Project No. 3023260

7009 comments for revised application 3.18.18.pdf

Please consider these comments when you re-evaluate the proposed contract rezone of the 7009 Greenwood to the currently undefined "NC55" zone (Proj. No. 3023260). This letter is to urge you to NOT recommend approval of the proposed contract rezone for 7009 Greenwood Ave N in the Phinney Ridge neighborhood.

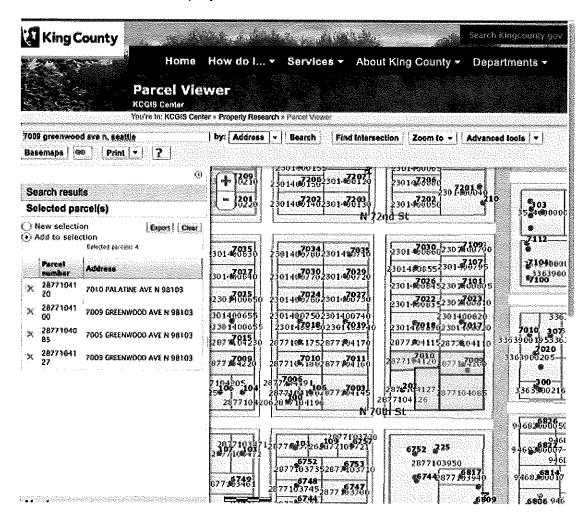
- 2. SMC 23.47A.014.B.3., requiring a setback of 15 feet for portions of structures above 13 feet in height up to 40 feet, and an additional setback at the rate of 2 feet per 10 feet of height above 40 feet,
- 3. SMC 23.47A.014.B.5, prohibiting an entrance, window, or other opening closer than 5 feet to an abutting SF lot.

The site plan drawings at A100 – A206, and G006.1 show these violations, and the west and south elevation drawings on Site Plan page A310 show the visual impact of these violations.

Zoning map (#39, partial) showing 7009 project area

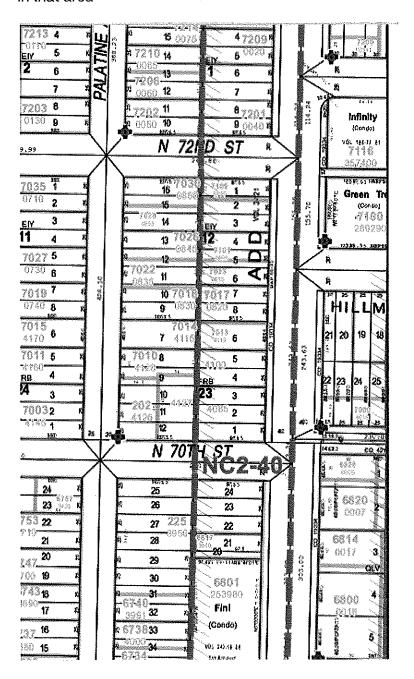
-specific location: on 70th above the "NC2-40" text, at parcels 1-5 (the two commercial lots); parcels 9 (partial) -12 (vacant SF lot on 70th) and the lot labeled "7010" on Palatine (that has parcel 8, and part of 9)

-shows zoning line running N/S at the rear property lines for several blocks in that area

LOCATION OF SIDE / REAR YARD SETBACK

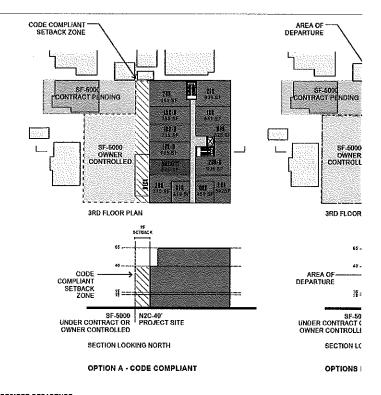
The project seeks a departure from the setback requirement for a setback abutting a residentially zoned lot at the lot and the SF-5000 zoned lot to the northwest that is under negotiation to be owned by 70th Greenwood Avenue site includes the SF lots immediately adjacent the NC2 zoned lot and residential setbacks will be met between the development site and any adjacent lots. A departure from this requirement is sought on the internal lot boundary (

the project intend to provide a 15' high retail space at the ground level allowing for more transparency at the ground space to the park beyond. The setback required above 13' would create an awkward roof in the northwest corner and costly for such a small area.
